**Changes highlighted are against drawing 'Unit 2
Elevations Drg No: 22113 - P2005 Rev: E' approved on 5
May 2022 (Application No. 22/00430/FUL)**

DZ3 Hinckley Park, Avery Way

Unit 2 - NMA App - Building Elevations

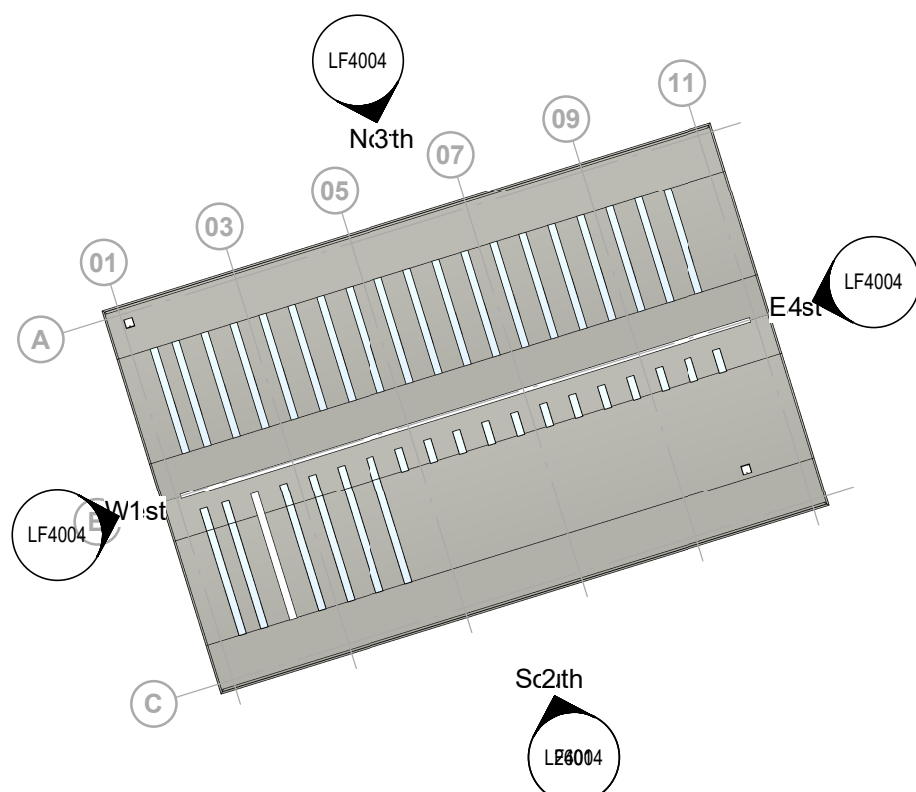
01 - Dock concrete prowall height amended.

02 - Addition of taller dock shelters.

03 - Revisions to louvre sizes.

**01 - Prowall reduced in
height from 5m to 4.8m.**

**02 - Dock door increased in
height from 3.5m to 4.5m.**

**03 - Louvres have increased in
width from 600mm to 1650mm
to reflect detailed M&E design.**

**03 - Louvre has decreased in
height from 1700mm to 1550mm
to reflect detailed M&E design.**
